TRANSMITTAL FORM

To: Muffy Walker P.O. Box 3755 (98124-3375) U.S. Army Corps of Engineers 4735 E. Marginal Way S. Seattle, Washington 98134-2385	Date: November 2, 2001 Project Number: 556-2912-001-03 Project Name: STIA MPU Natural Resource Mitigation
--	--

Responses to ACOE Questions on 26 October 2001 Submittals

RESPONSE TO ACOE QUESTIONS ON 26 OCTOBER 2001 SUBMITTALS

Pond F Infiltration Testing

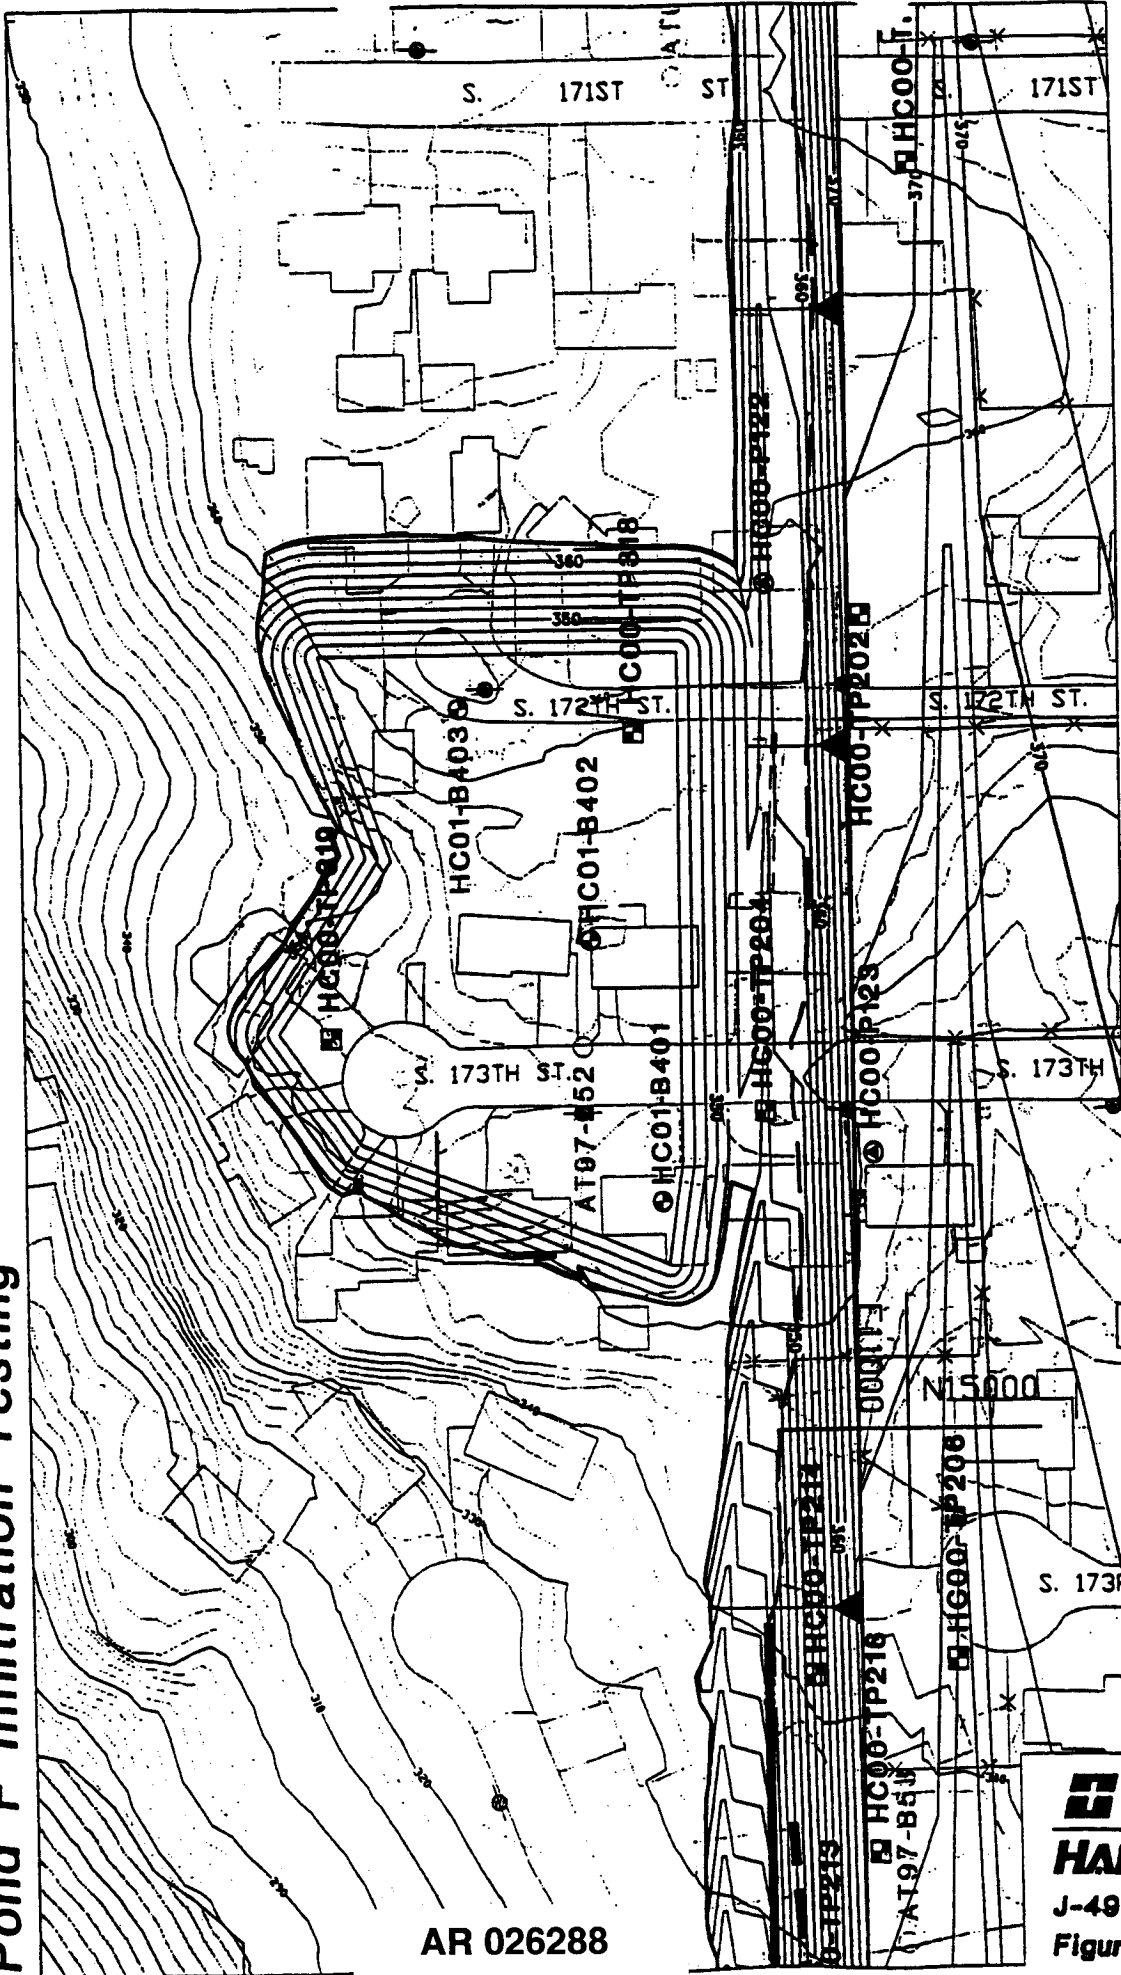
3. The Low-Flow analysis addresses impacts to Walker Creek, and a low flow vault is planned to mitigate low flow impacts. Infiltration has been evaluated and included where feasible. For Pond F, in the Walker Creek Basin, soil conditions were found to be unsuitable for infiltration (see attached memorandum by Hart Crowser (May 23, 2001)).

On April 25, 2001, investigative borings (designated HC01-B401, HC01-B402, and HC01-B403) were advanced east and northeast of the partially completed Pond F (see Figure 1). These three explorations revealed a surficial layer of silty, fine to medium sand approximately 5 feet thick overlying a dense to very dense, silty, gravelly, fine to coarse sand
